# 160 BURWOOD RD, CONCORD URBAN DESIGN REVIEW

## Final Report

Prepared for the City of Canada Bay Council  
by Studio GL

Job title	Urban Design Review 160 Burwood Road, Concord
Client	City of Canada Bay
Job number	20063
Report title	Draft Urban Design Review Report
File name	20063_BurwoodRd_UrbanDesignReview_PP2022.indd

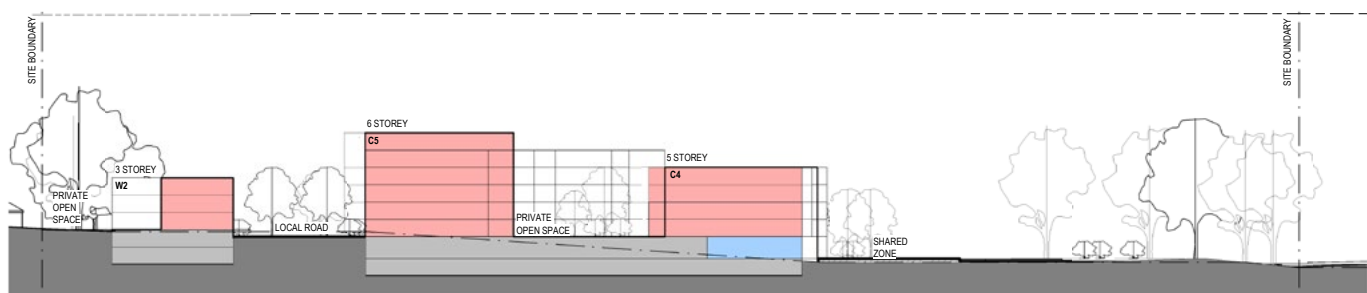
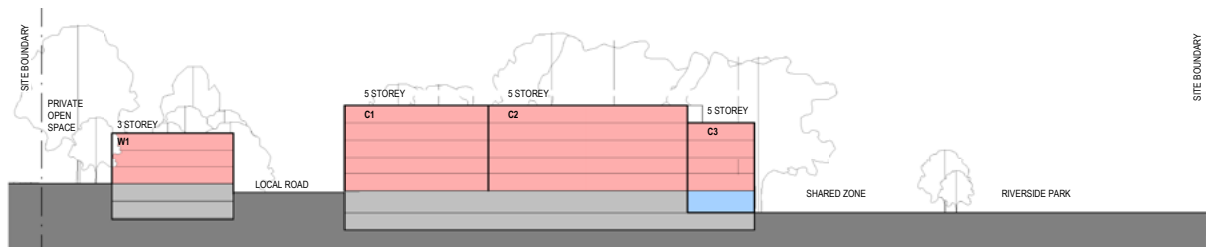
The PP (May 2022) identifies a change in building heights in the buildings in Block 2, Southern Edge when compared to the PP (Sep 2019) as follows:

- Building C8 - Reduced height on plan from 6 storeys to 5 storeys with a small reduction in height from RL 27900 to RL 26900.
- Building C4 - Remains at 4 storeys but has an increase in height from RL 21900 to RL 23800
- Building C9 - Remains at 3 storeys but has an increase in height from RL 16500 to RL 17600

Figure 26 Key setback and separation distances highlighted on Roof Plan (BVN May 2022).

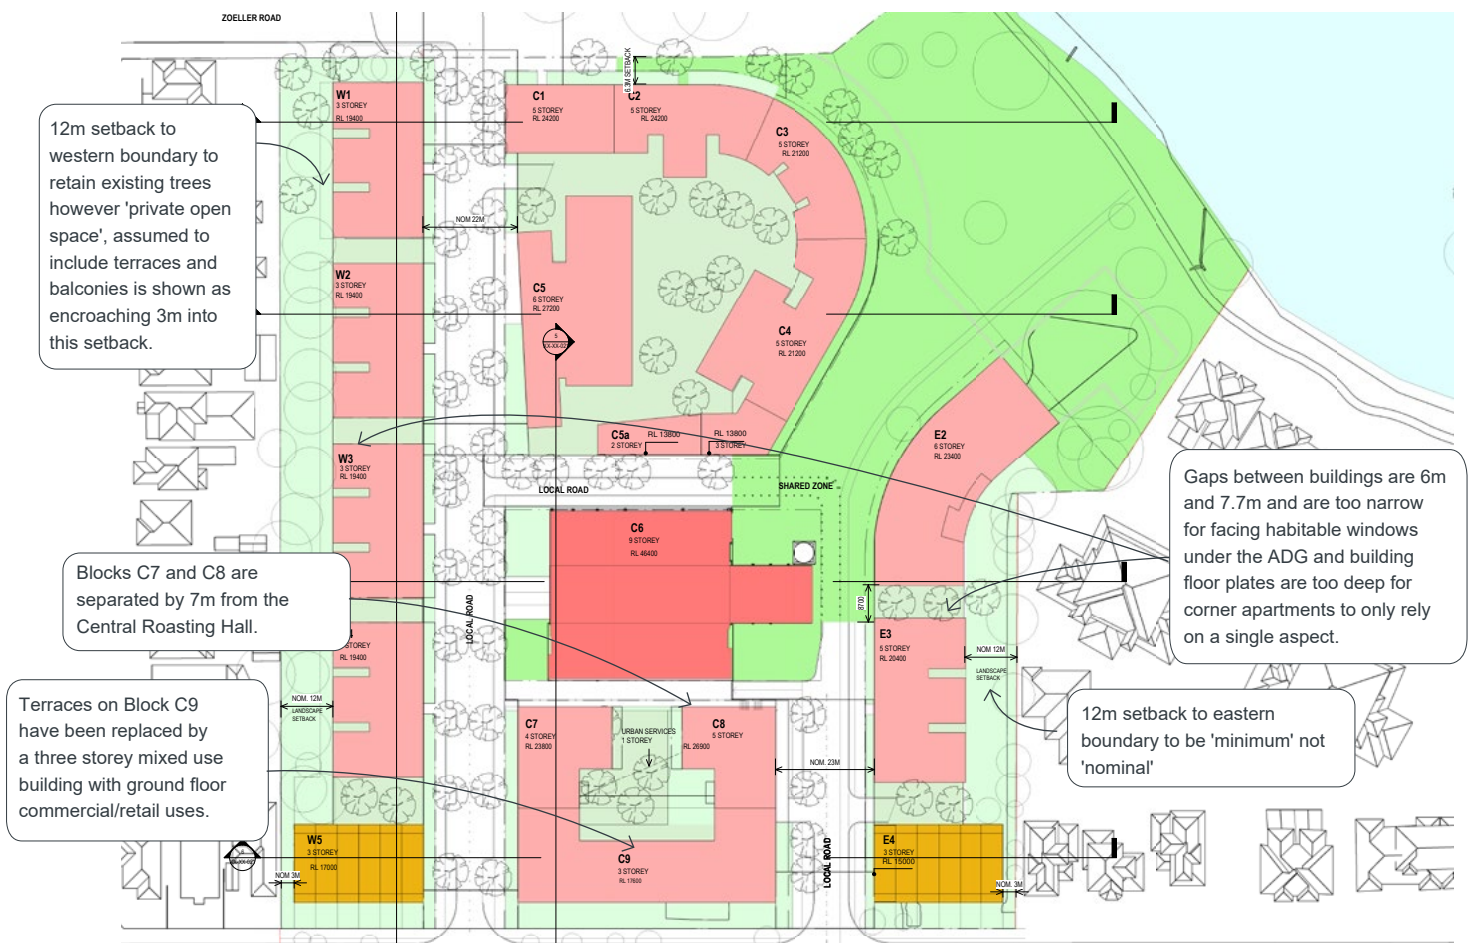
The amended Concept Plan shows setbacks as "nominal" rather than "minimum" dimensions, which suggests these dimensions may be flexible. The amended PP (May 2022) does not specify all setbacks, street widths or open space areas. The detailed DCP exhibited with the PP incorporates clear plans with minimum setback distances to all boundaries and minimum street widths and open space areas. It is recommended that these are updated and adopted to provide certainty for future development of this site.

Figure 38 Proposed FSR map (Source: LFA 2022, p49)

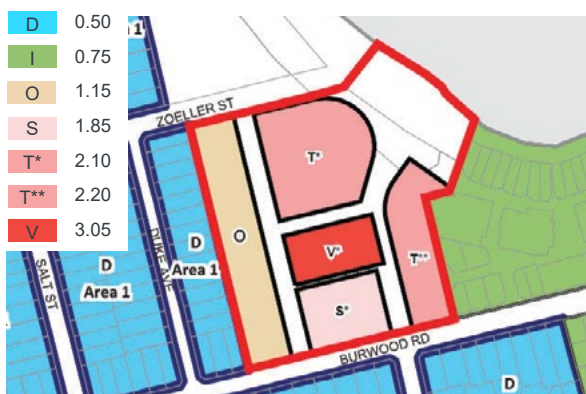
The amended PP (May 2022) identifies net FSRs for individual blocks. This diagram (Figure 38) clearly shows that net densities are predominantly much higher than 1.25:1, ranging from 1.15:1 to 3.05:1.

The PP (May 2022) includes a proposed LEP map for maximum FSR and this is shown in Figure 38.

Figure 39 Recommended FSR map prepared by Studio GL, 2022

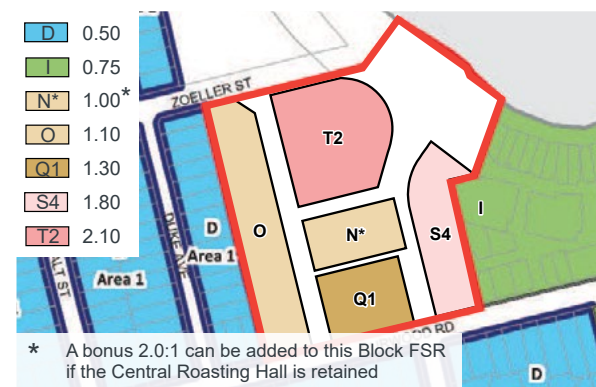
These changes result in a recommended permissible density of 0.96:1 (approx. 38,000m<sup>2</sup>). If the Central Roasting Hall is retained, a bonus FSR of 2.0:1 (approx. 5,900m<sup>2</sup>) can be applied to Block 4, resulting in an increased total FSR of 3.0:1 for this block and an increased overall gross site FSR of 1.11:1 (approx. 43,900m<sup>2</sup>). These calculations are shown in Figure 37.

These amendments are reflected in Studio GL's recommended LEP FSR map (Figure 39) below.

Figure 40 Studio GL annotations overlaid on L-01 Plan (BVN 2021)

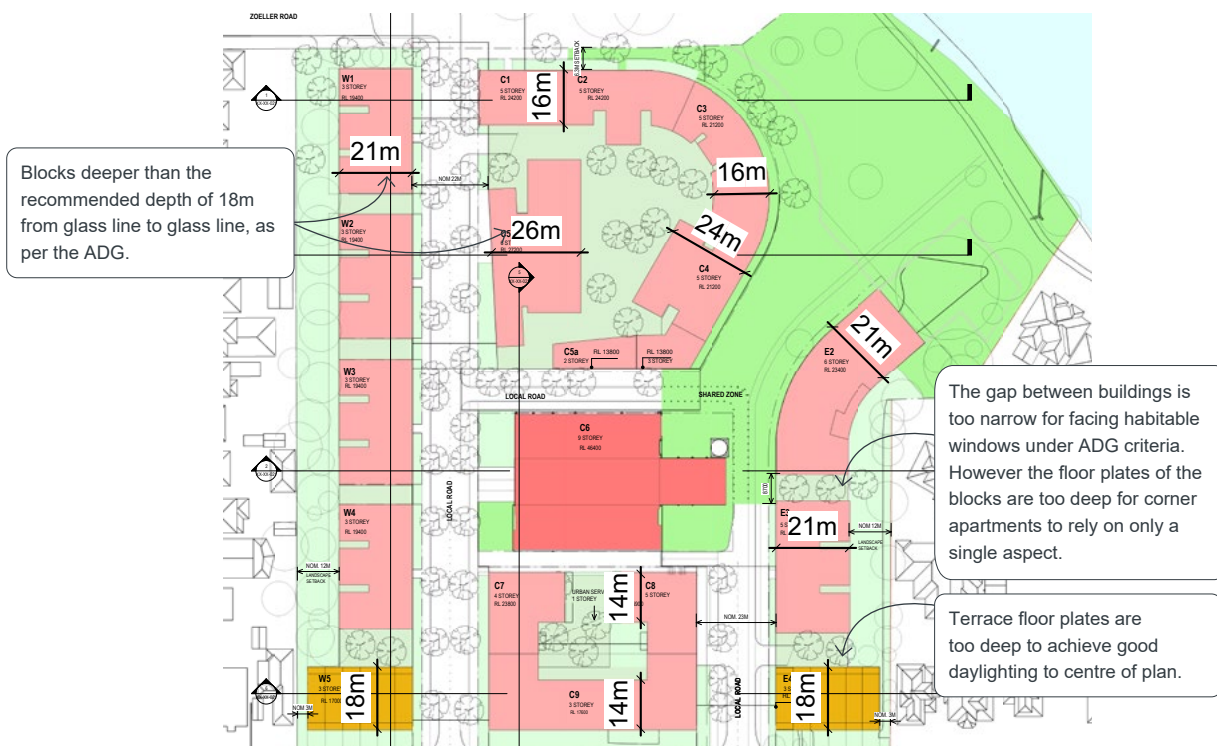
Building depth is an important factor to consider when setting density controls, as the depth of a building's floor plate has a direct relationship with the total floor area achieved. The plan below (Figure 40) illustrates the range of building depths within the amended PP (May 2022). The plan shows a number of buildings deeper than 18m which create deep floor plates that make it difficult to achieve good residential amenity, and meet sunlight and natural ventilation requirements required by the ADG. It is recommended that building depths over 18m are reduced to ensure a high level of residential amenity can be provided, that is appropriate to the suburban context.

The ADG also notes that building depths should include balconies. Balconies have not been indicated on the architectural plans within the amended PP (May 2022) and have not been included in the GBA calculations. As shown in the Communal Open Space Diagram (BVN May 2022) the provision of balconies and roof top communal open spaces will create additional bulk to the development, reduce privacy distances, and further reduce internal amenity on blocks deeper than 18m. It is recommended that balconies are accommodated within the proposed building envelopes.

Figure 41 Studio GL annotations overlaid on extract from L-01 Plan (BVN 2021)

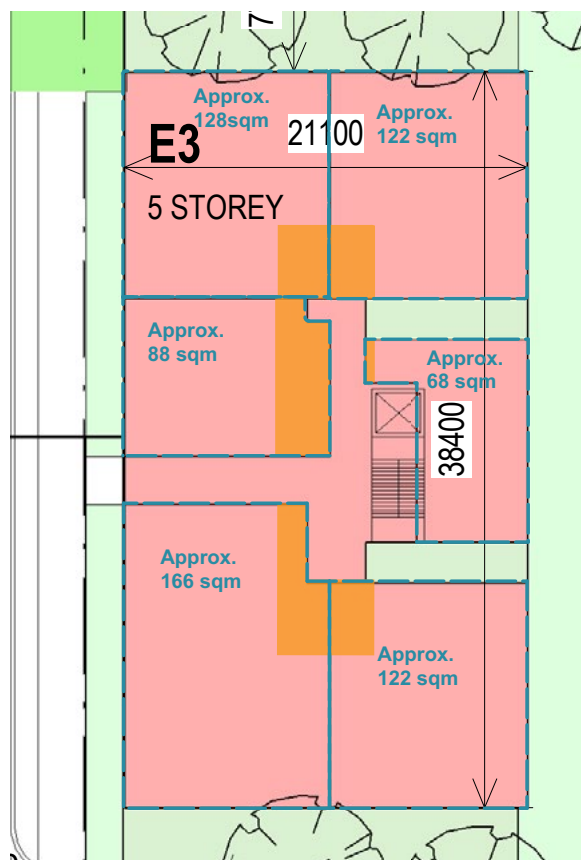
In addition to building depth, the length of a building also affects cross ventilation; long uninterrupted blocks have fewer corner apartments than multiple separate buildings. The annotated plan of a typical block (Figure 41) illustrates that the deep 21m floor plate creates deep apartment plans; where a significant portion of the apartment is greater than 8m from the facade.

Figure 46 Recommended Land Zoning LEP map prepared by SGL, 2022

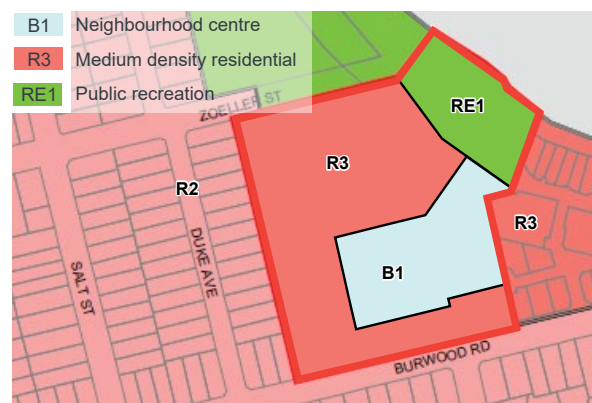
- a) a minimum provision of ~~10,000~~ **7,500** square metres of non-residential gross floor area is provided.
- b) a minimum provision of 3,000 square metres of light industrial floor space area is provided.
- c) shops have a maximum gross floor area of 1,000 square metres per tenancy; and
- d) light industrial uses are located on the ground floor (inclusive of the lower and upper ground floor) and provide floor to ceiling heights, **servicing and access** that accommodate the activities and equipment of the light industrial use(s).

Figure 47 Plan indicating public open space and privately owned publicly accessible open space (Source: BVN 2022, p14)

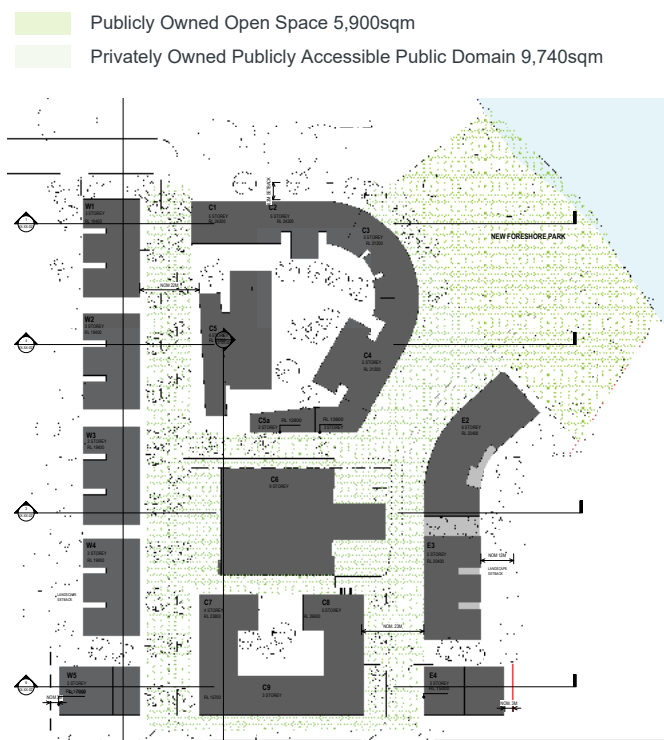
The Concept Plan includes a "Public Domain Plan" that identifies public open space and privately owned publicly accessible public domain (see Figure 47). 44% of the site area is identified as "Public Realm" in the Urban Design Report (Hatch Roberts Day 2022, p.6), and this includes the proposed plaza and foreshore park, the two proposed north-south roads and east-west street connections. This area also includes most of the front setbacks along the new roads and along Zoeller Street and the side setbacks of Block 2 and 4. Interestingly, the ramps leading to the Central and East basements are also identified as 'private open space'.

When Studio GL calculated the "Public Realm" area excluding the building front setbacks, this area amounts to 39% of the site area (see Figure 48). The Urban Design Report (Hatch Roberts Day 2022, p.6) states that 51% of this "Public Realm" is occupied by the new foreshore parkland and plaza. Studio GL calculated that the area zoned RE1 Public Open Space accounted for only 38% of the overall 'public realm' (see Figure 49).

Figure 51 Overshadowing analysis diagram at 2pm on 21 June (BVN, 2022) with mark-ups by Studio GL

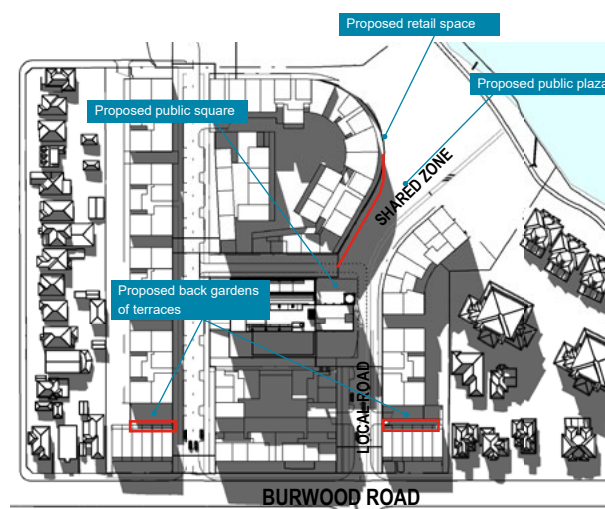
The proposed back gardens of the three (3) storey terraces in Block 1 and Block 3 of the amended PP (May 2022) will not achieve 2 hours of solar access between 9am to 3pm. It is also concerning that the proposed location of the basement ramps will not allow for the provision of back gardens for many of these terraces. It is recommended that the proposed ramps be relocated to allow all terraces to have back gardens of appropriate size and amenity.

Figure 57 Proposed Foreshore Building Line, LFA 2022

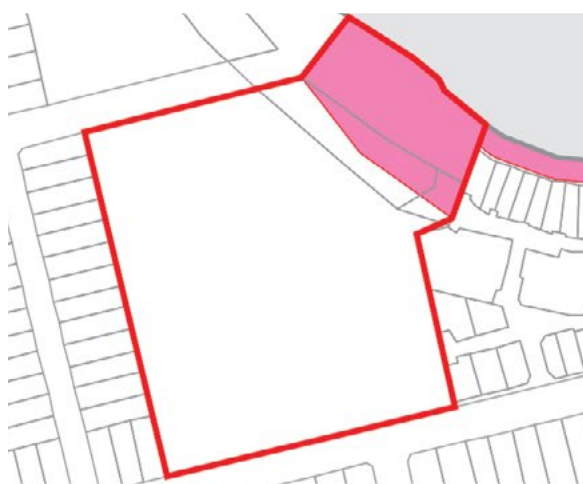
The amended PP (May 2022) suggests that the 'Foreshore Building Line Map Sheet 004' of the CBLEP 2013 be "Amend(ed) to apply to the portion of the site proposed to be zoned RE1 Public Recreation. No change to the written instrument is proposed". However, the Foreshore Building Line in the PP (May 2022) LEP map (Figure 57), appears to be inconsistent with the proposed RE1 Public Recreation area/ boundary shown in the architectural Concept Plans. It is recommended that the precise location of the RE1 boundary is clarified by the applicant and provided to Council.

Figure 58 Recommended Foreshore Building Line, annotated, Studio GL, 2022

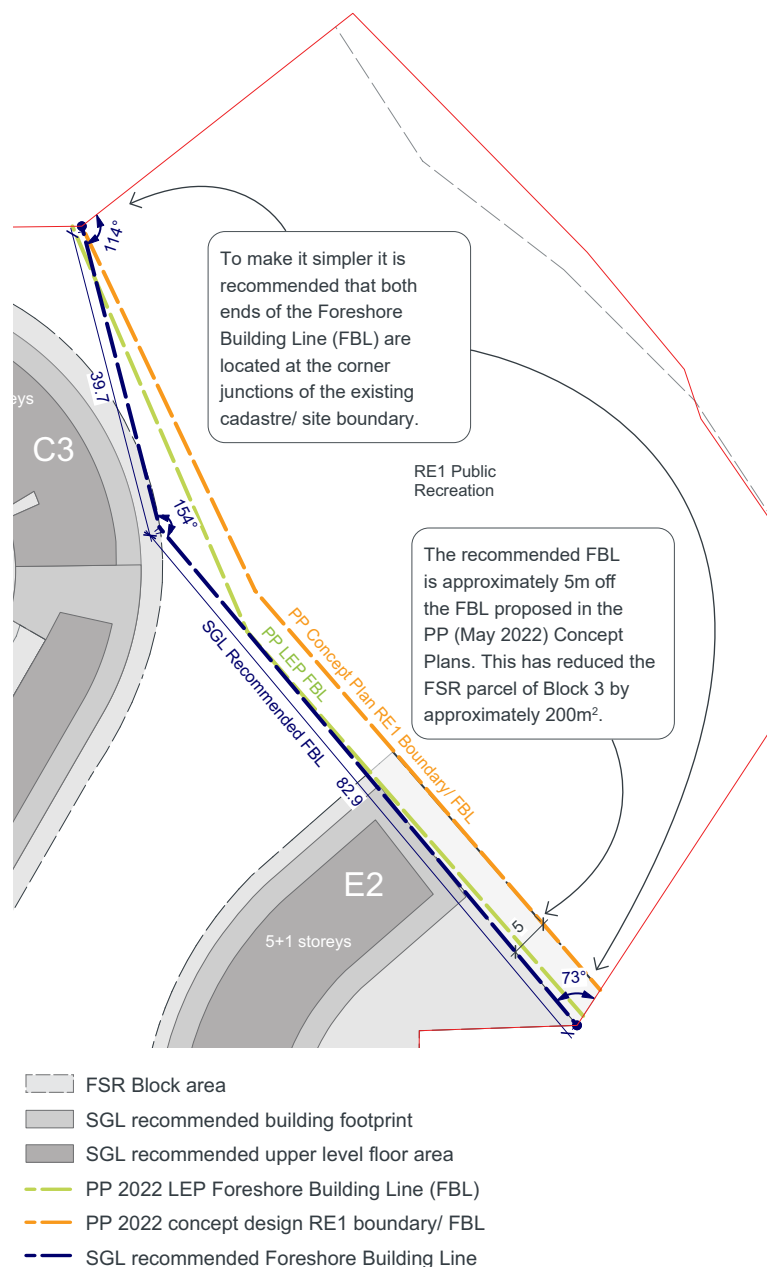
Studio GL also recommends adjusting the proposed Foreshore Building Line so that it clearly defines the proposed maximum building footprint. This modification is shown by the navy line in Figure 58. This will strengthen the planning controls and further ensure no built form occurs beyond the building envelopes proposed in the Concept Plan.

Figure 60 Recommended Land Zoning map prepared by Studio GL, 2022.

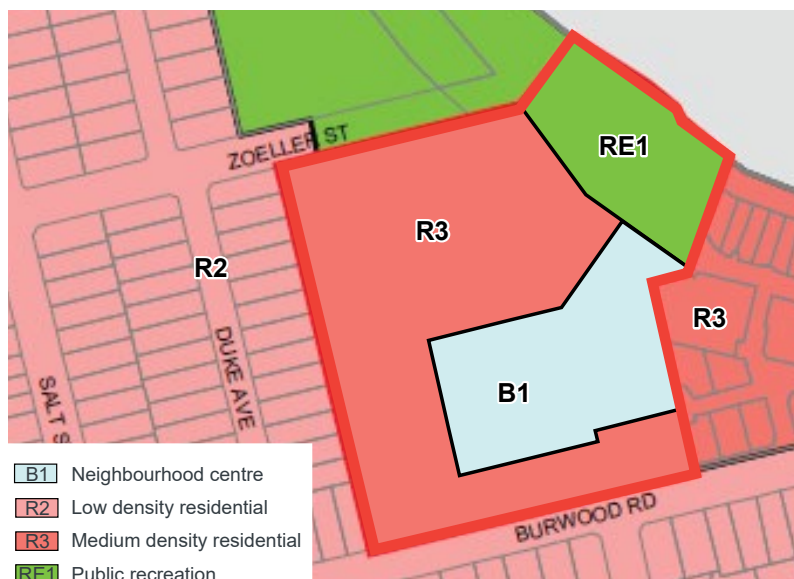
An amendment to the proposed Land Zoning Map can be found at Figure 60. The recommended change to the LEP map increases the amount of land zoned B1 (an increase of approx. 2,000m<sup>2</sup>), however this additional area does include roads (approx. 750m<sup>2</sup>) and the 12m side setback between the eastern site boundary and buildings E2/E3 (approx. 1,000m<sup>2</sup>).

Figure 66 Concept Plan elevations (BVN 2022) overlaid with PP (May 2022) LEP maximum Height of Building (in blue) and Studio GL's recommended maximum LEP building heights 2022 (in red)

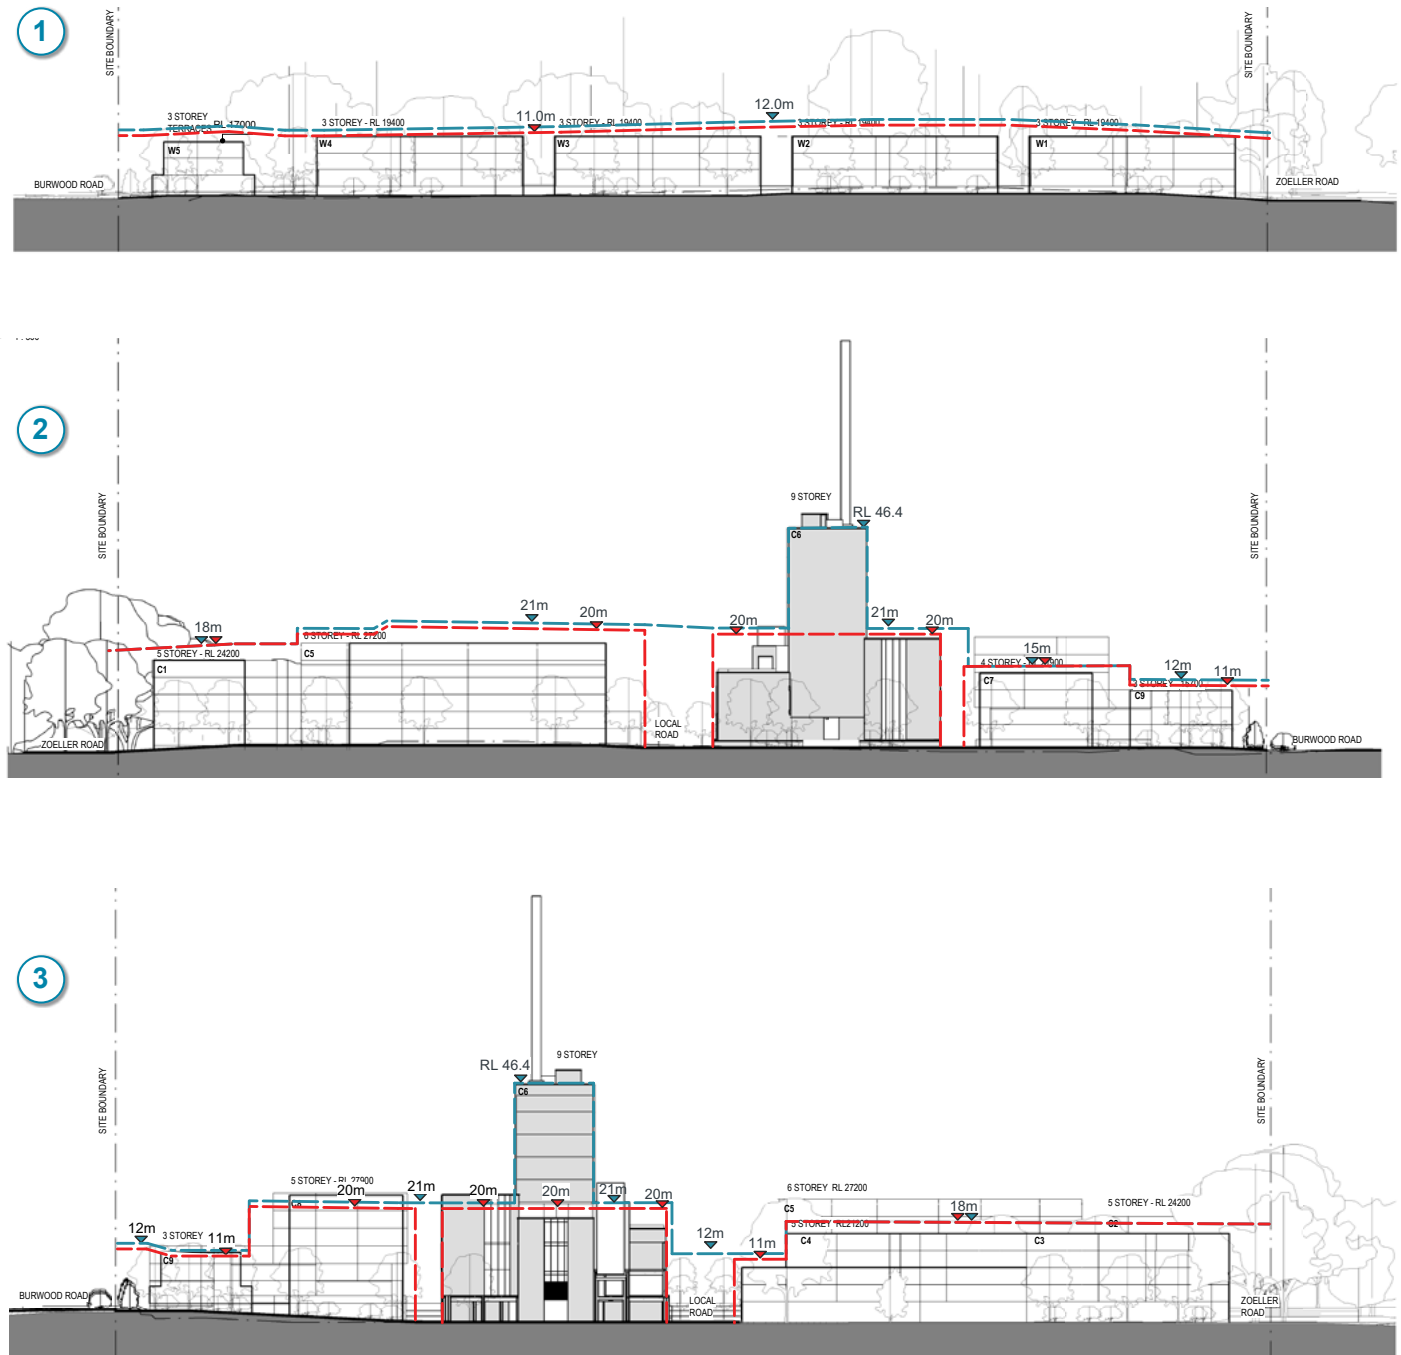
The maximum building heights in the proposed amended LEP map identified in the PP (May 2022) are greater than needed to accommodate the proposed built form and could, potentially, encourage even taller development in the future. To avoid this the following is recommended (as shown in Figure 64):
